Technical product information

Topic	New Continental GT and New Continental GTC - Rear quarter glass not fully closing
Market area	Bentley: worldwide (2WBE)
Brand	Bentley
Transaction No.	2058424/2
Level	EH
Status	Approval
Release date

Figure 1

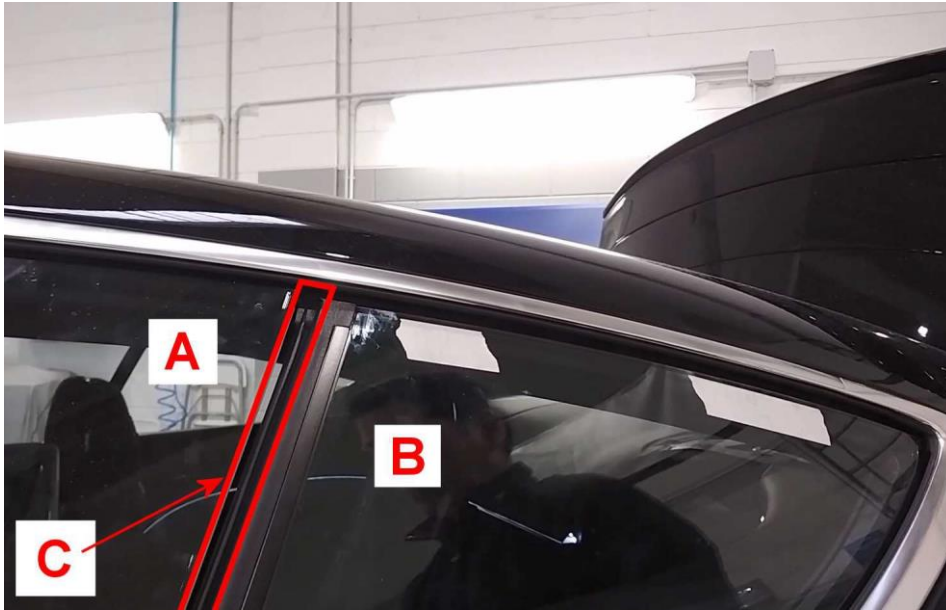
Referring to Figure 1 - During the window and/or door close operation, the front door drop glass closes and seals (Point A) however the rear quarter glass does not fully close and seal (Point B) leaving a gap between the front and rear glass (Point C)

- 1) Ensure a suitable battery charger is correctly connected to the vehicle electrical system for the duration of this procedure
 - Switch on ignition, ensure the ignition is on for the duration of the update
 - Connect the Bentley approved diagnostic tool to the vehicle On Board Diagnostic (OBD) socket. NOTE: The process is Initiated via Bentley diagnostic tool (VAS6150C or similar) using a hard wire connection to the vehicle OBD socket, Bluetooth connections should not be used under any circumstances

- 2) From the diagnostic tool main desktop select the Off Board Diagnostic Information System 
 - Select – Start diagnosis
 - Select – Model / Engine
- 3) Referring to Figure 1 - Select Special functions (1), Select SVM – Problem related Hardware/Software Update (2), Select Perform test (3)

4) Referring to Figure 2–At the SVM screen (1) enter the specific SVM code 370BYZDC01 and then select Adopt (2)

5) Referring to Figure 3, Check you have entered the correct SVM code (1) and select Yes (2) and follow all on screen prompts
